# Air Quality Review V1 for 20/01686/FULL - Development Site at Padnall Lake, Padnall Road, Romford, RM6 5ER

Prepared by the Centre for Health Services Studies, 25/11/2020, Professor Stephen Peckham & Dr Ashley Mills. Contact: ajsm@kent.ac.uk

Site	Development Site at Padnall Lake, Padnall Road, Romford, RM6 5E
Applicant	London Borough of Barking and Dagenham (LBBD)
Barking and Dagenham reference	20/01686/FULL

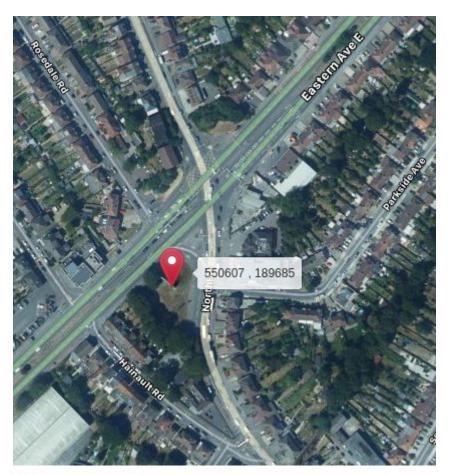
- 9. On page 2 of the developers AQA [2], the developer states, with respect to the air quality assessment scope and methodology, that:
  - "The proposed scope and methodology were approved by the LBBD EHO in an email on 16 March 2020 with the proviso that the baseline data for the assessment be representative."
- 10. In Section 6.1.2 of the developer's AQA, they specify which data is used for baseline verification, and describe two diffusion tubes located in the Borough of Havering. These are a triplicate: HAV13,14,15 and a site HAV39. These are described as being "between 2 and 3 km east of the site" (page 20, para 5), but their Table 6.1 on page 20 states that they are ~2.2km and ~3.5km from the site respectively so would more accurately be described as being between 2 and 4km from the site.

HAV 13,14,15 Aerial

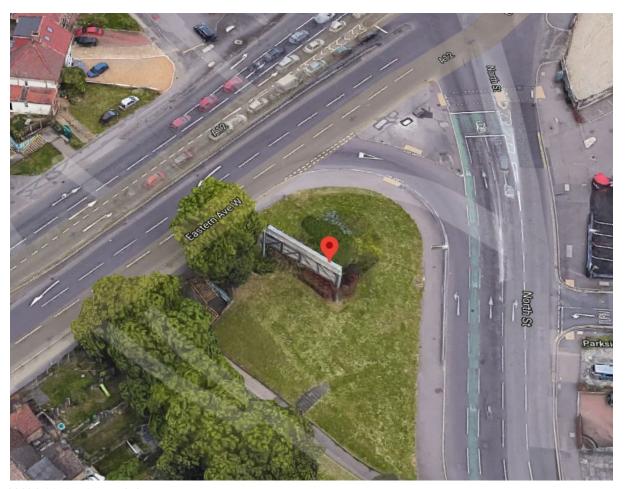
12. In Appendix 3 of the developers AQA, they outline the model verification procedure and state that the model is verified using two diffusion tubes located in the Borough of Havering.

Both of these sites are quite atypical for Roadside sites, the first being not directly on the A12, and the second being in a green area set back far from the A12 and partially occluded

by trees from the road. From the perspective of the A12 they both set back considerably and it is a stretch to call these "roadside" in the context of the A12.
